Imray Correction Notice ICC5-3

7 September 2021

Chart C5 WGS 84 Edition 2016

Block correction C5 (Plan A)
ILNW 374/18

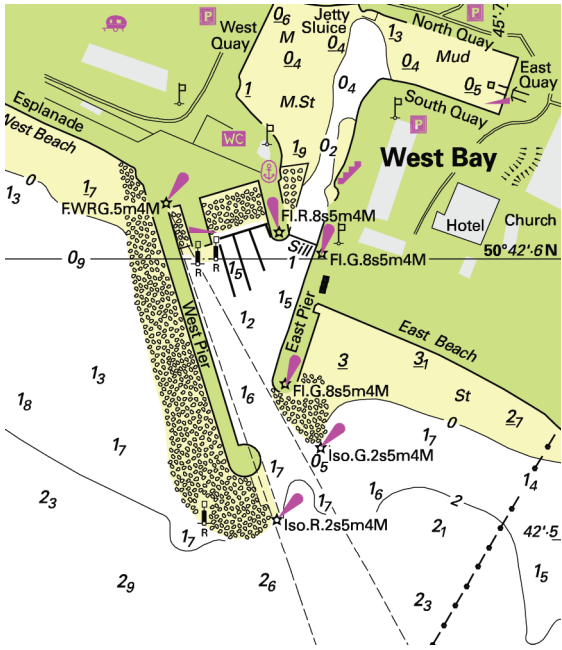
8 **Bridport Harbour (Plan A)**

Insert accompanying block correction centred on 50°42'·58N 2°45'·83W (ILNW 374/18)
